ZONING AMENDMENT,
PLANNED UNIT DEVELOPMENT &
SUBDIVISION STAFF REPORT

Date: April 6, 2006

McMurray Place, LLC

SUBDIVISION PLAT

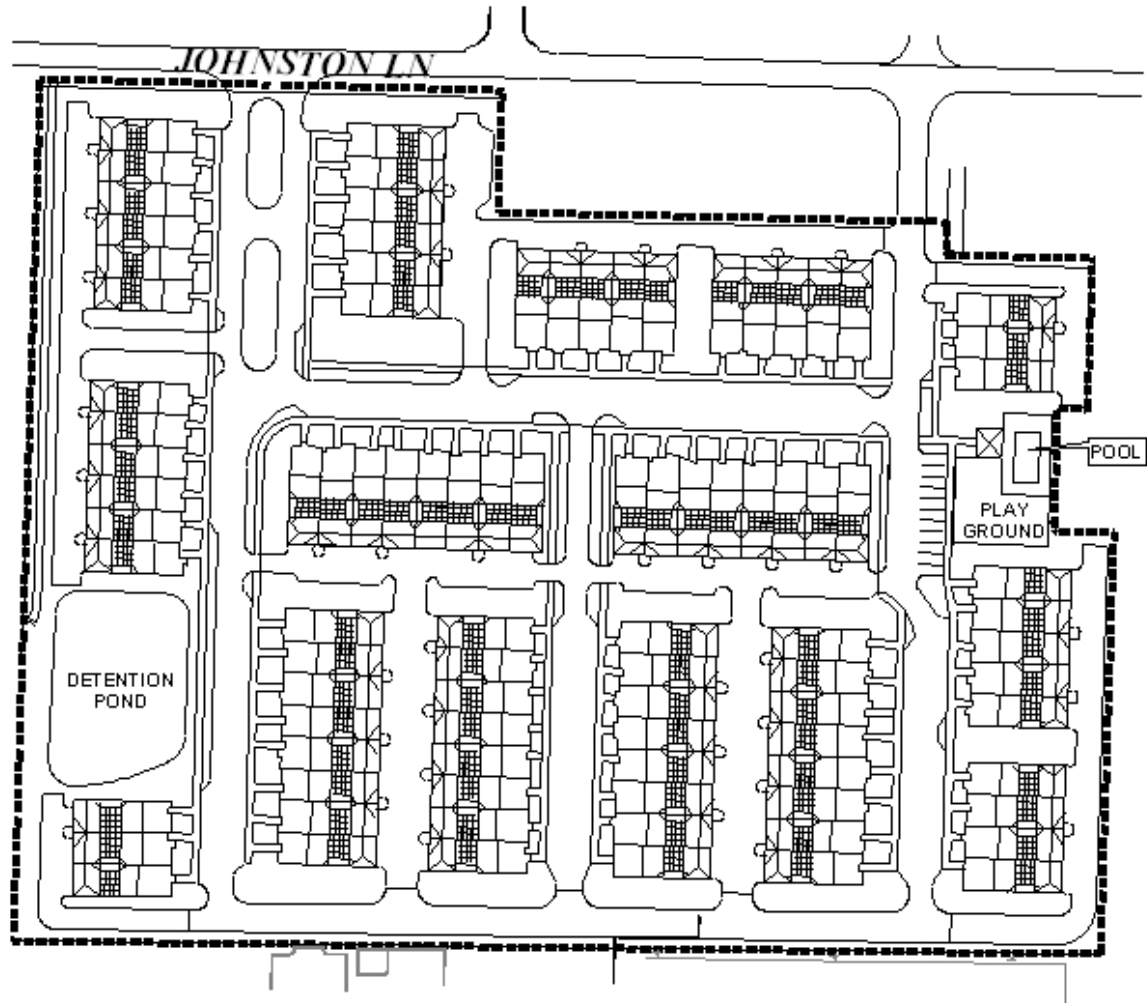
The minimum building setback line required in Section V.D.9. of the Subdivision Regulations is not shown for the lot, but would be required on the Final Plat. The building setback line should be a minimum of 25-feet from the future right-of-way for Johnston Lane, and from all unopened rights-of-way that abut the proposed lot.

As previously mentioned, unimproved rights-of-way are included within the bounds of the proposed Lot. Since it is the intent of the applicant to utilize the land for private use, the applicant must have the rights-of-way vacated by the City before a Final Plat can be recorded.

Subdivision: The Subdivision request is recommended for Tentative Approval, subject to the following conditions: 1) depiction of the 25-foot minimum building setback line; and 2) completion of the vacation process for existing rights-of-ways within the proposed subdivision.
